RE: Increased Structural Resiliency for Part 9 Buildings

IMPROVING THE STRUCTURAL RESILIENCY OF PART 9 BUILDINGS IN HIGH WIND EVENTS

**Presented to: Ministry of Municipal Affairs and Housing
Province of Ontario**

Michael Janotta, P.Eng., CBCO
Chief Building Official
City of Barrie
May 18, 2022

Appendix Information:

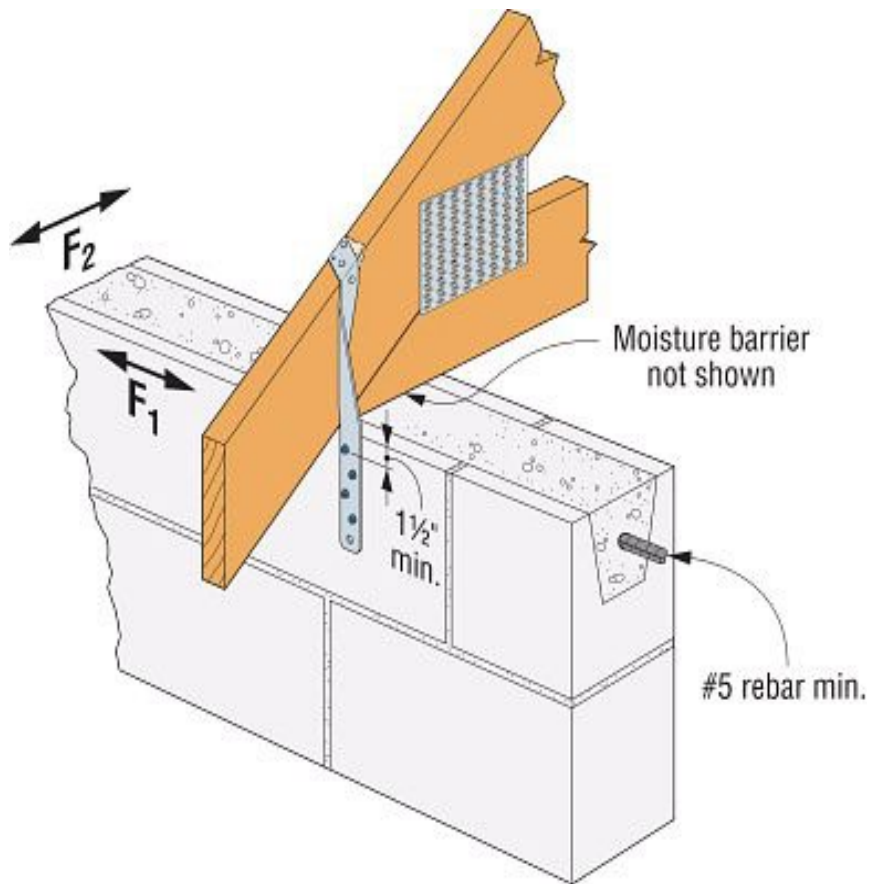
Except for single story buildings not exceeding 20m² in area, roof framing members supported by walls, beams or lintels shall be connected to their supporting member to resist a factored uplift of

- i) 2.5 kN where roof framing is at 406 mm o.c.
- ii) 3.7 kN where roof framing is at 610 mm o.c., or
- iii) 6.0 kN/m for spacing of elements other than specified above

(See appendix for typical connector options for wood frame and other walls. Example pictures included below).
